Addendum No. 003

**Subject: Rhawnhurst Elementary School- Additions and Renovations
SDP Contracts No. B-070, B-071, B-072 and B-073 of 2019/20**

**Location: Rhawnhurst Elementary School
7809 Castor Avenue
Philadelphia, Pennsylvania 19152**

This Addendum, dated March 30, 2021 shall modify and become part of the Contract Documents for the work of this project. Any items not mentioned herein, or affected by, shall be performed strictly in accordance with the original documents.

DRAWING TITLE
FIRST FLOOR DEMOLITION
PLAN UNITS "A" & "B"

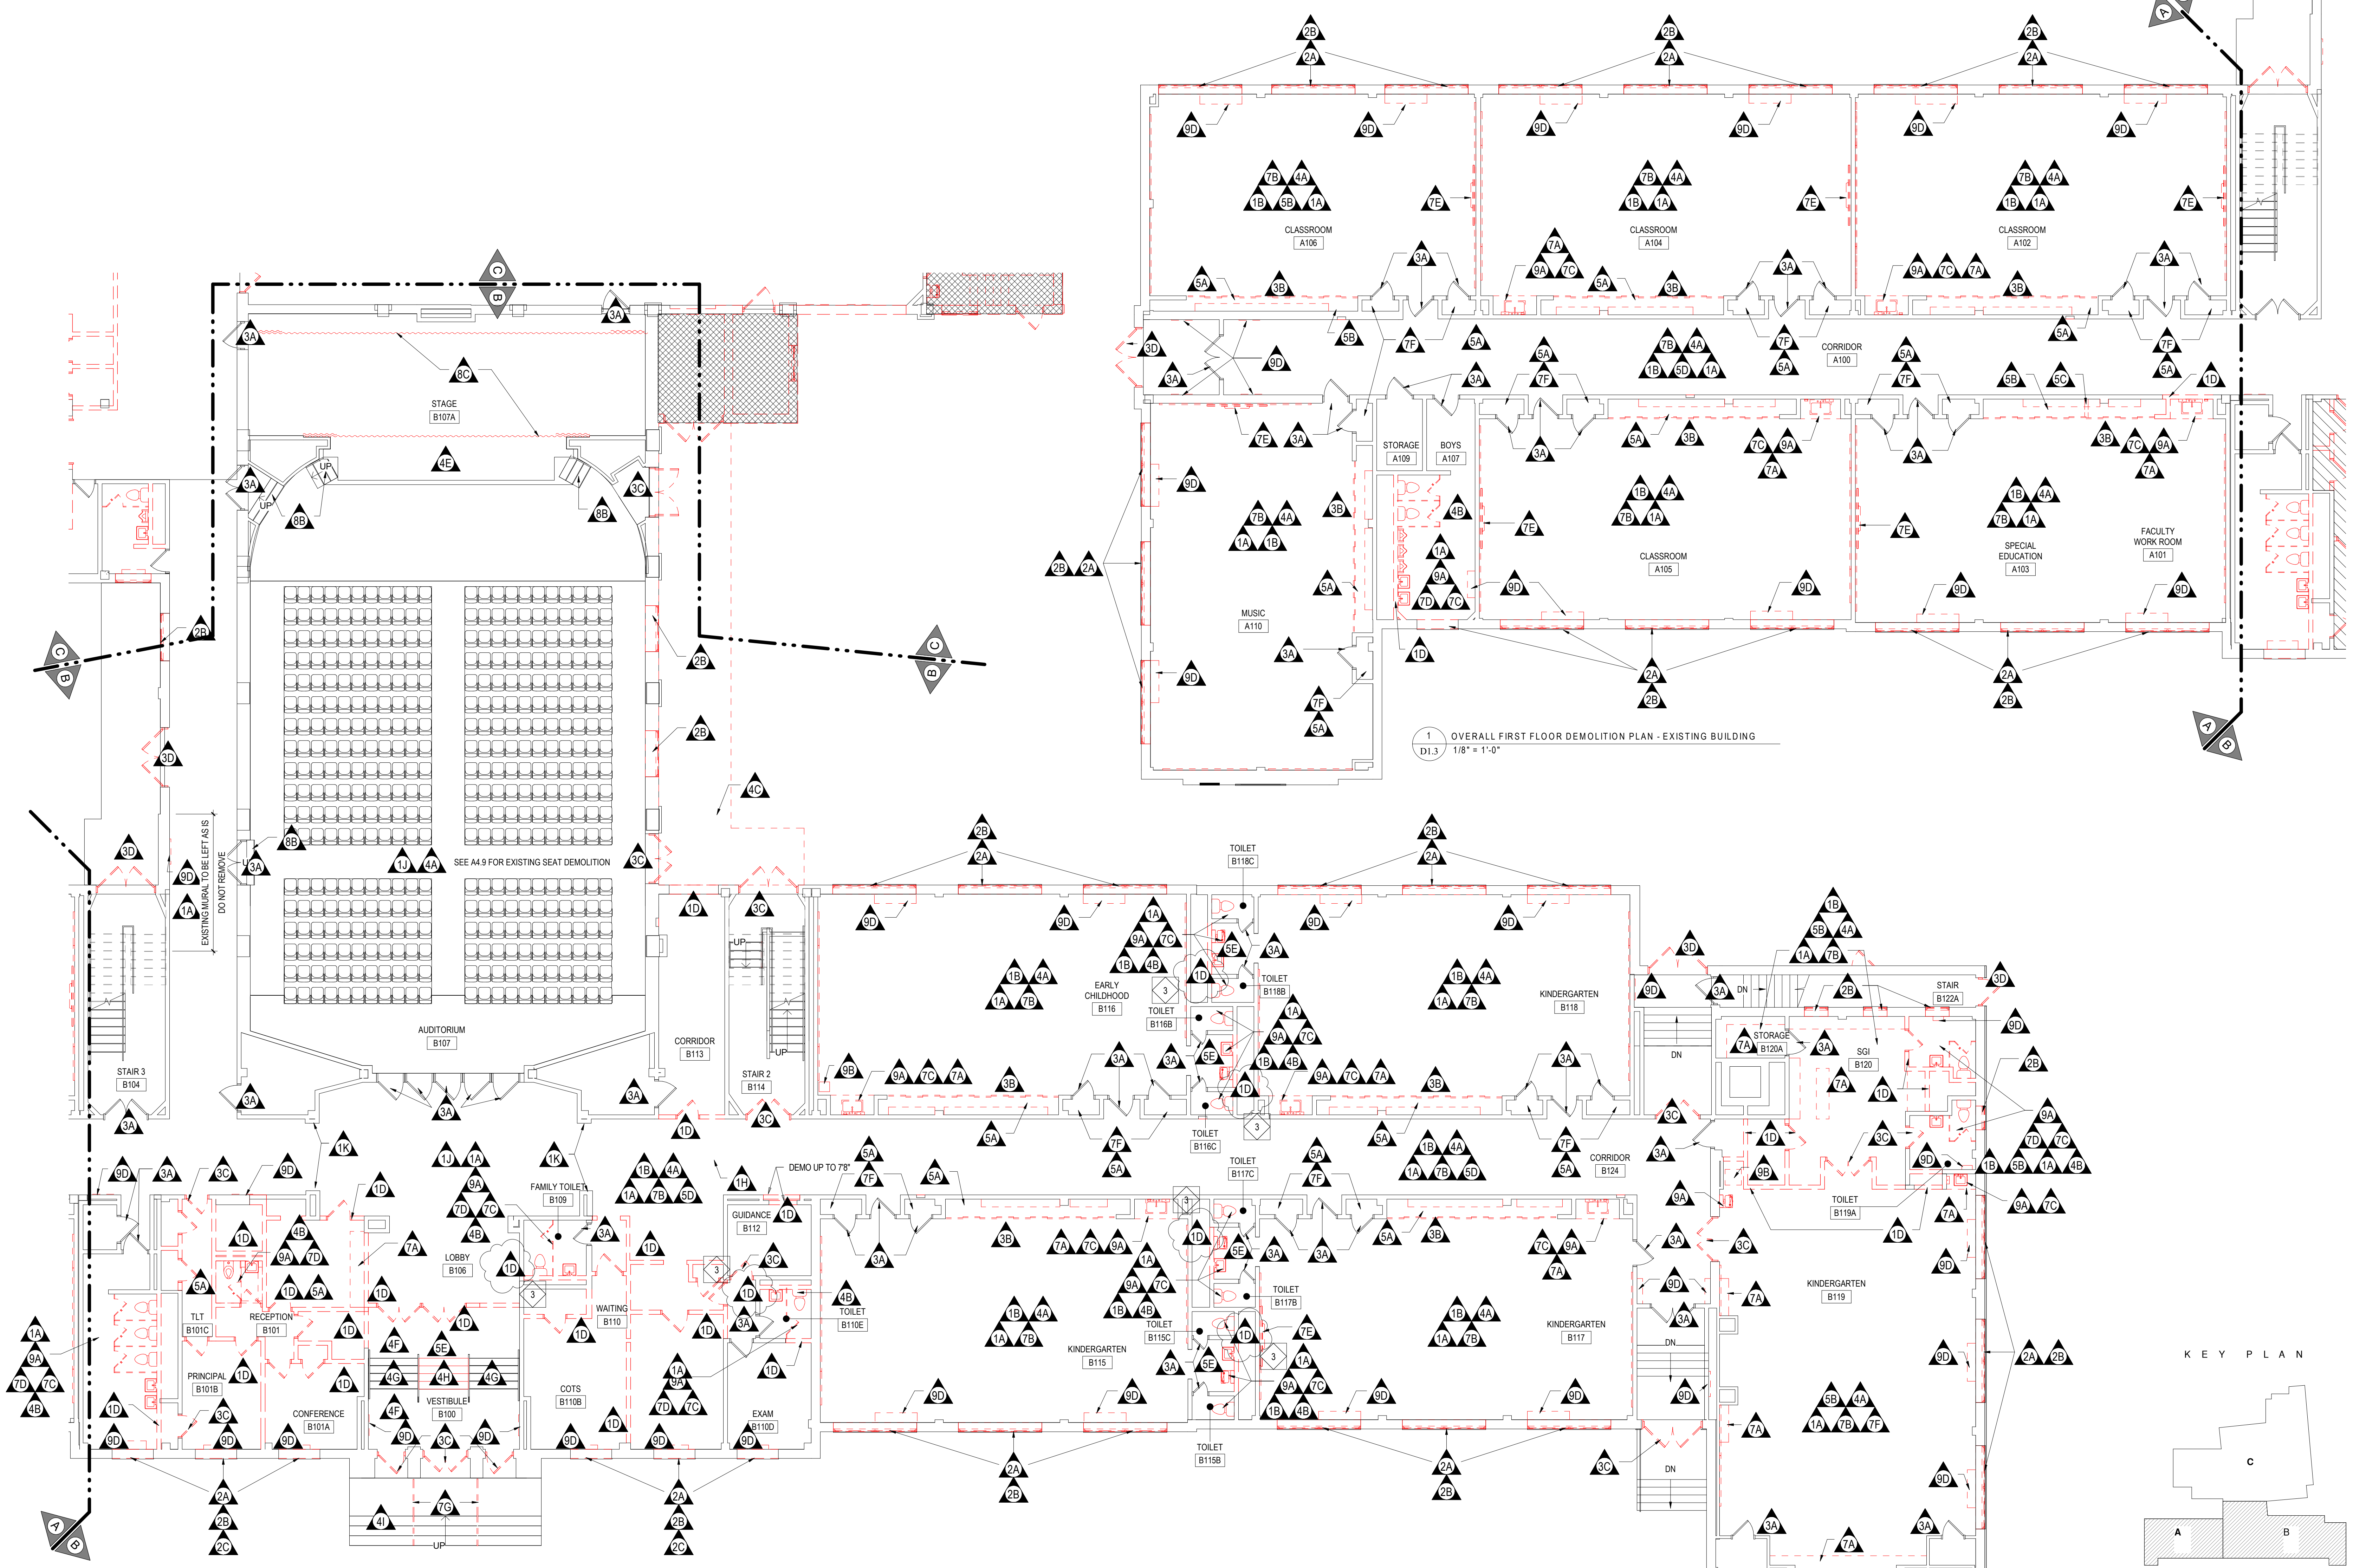
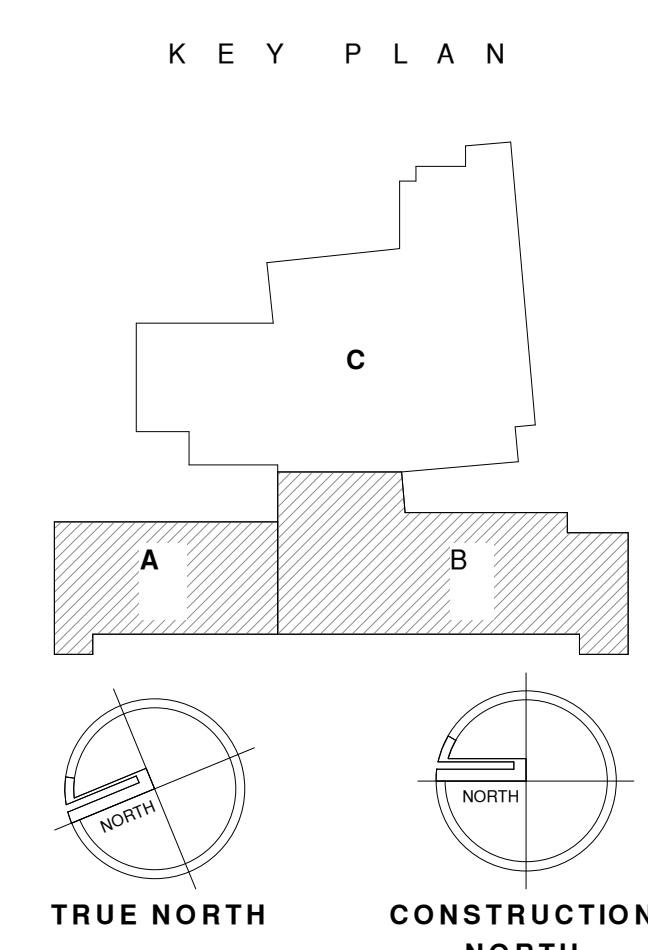
1. **REPLACE** D1.3 in its entirety as part of Addendum #3. Chase walls are being demoed in B109, B110E, B115A, B116A, B117A and B118A.

FIRST FLOOR PLAN UNIT "B"

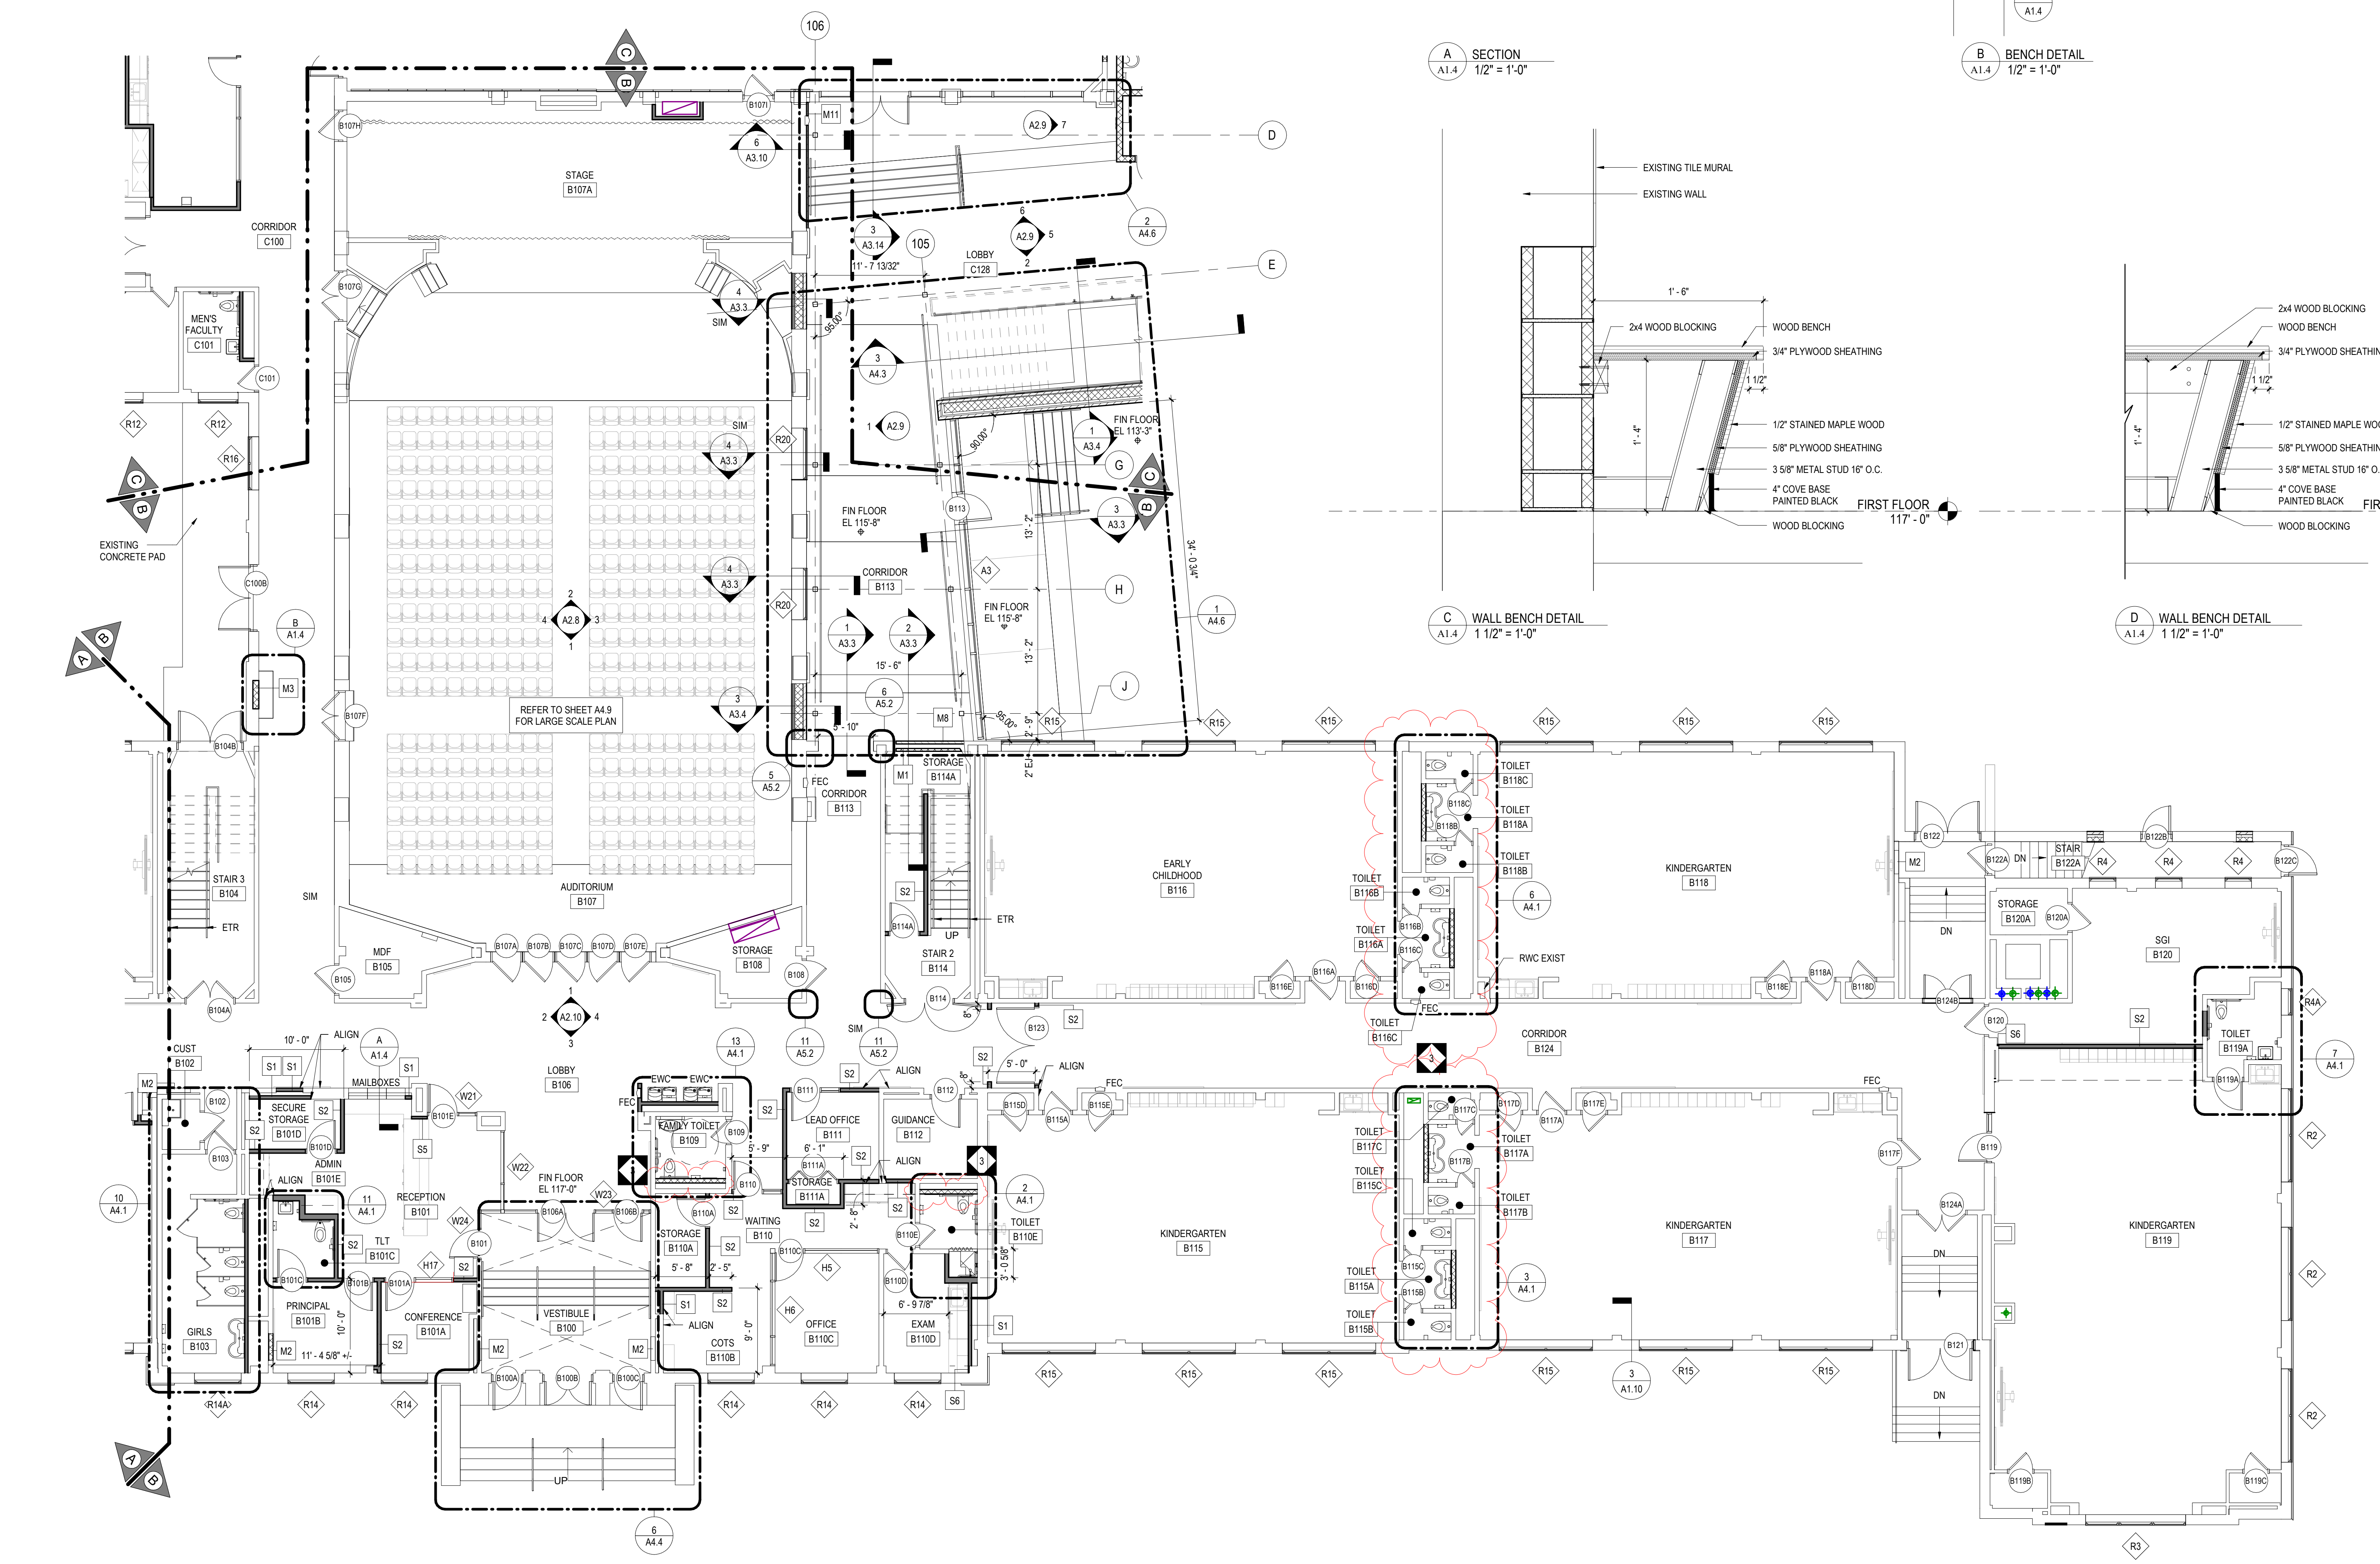
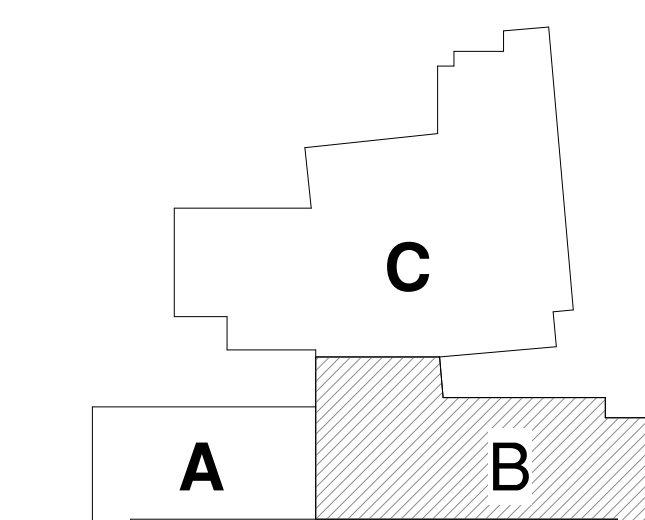
1. **REPLACE** A1.4 AND A4.1 in their entirety as part of Addendum #3. Walls are being demolished and replaced as indicated on the revised drawing to allow for plumbing demolition and replacement in the plumbing chases. These walls include B109, B110E, B115A, B116A, B117A and B118A. General contractor shall coordinate for the new installation of new plumbing and penetrations, sleeves etc. through these walls.
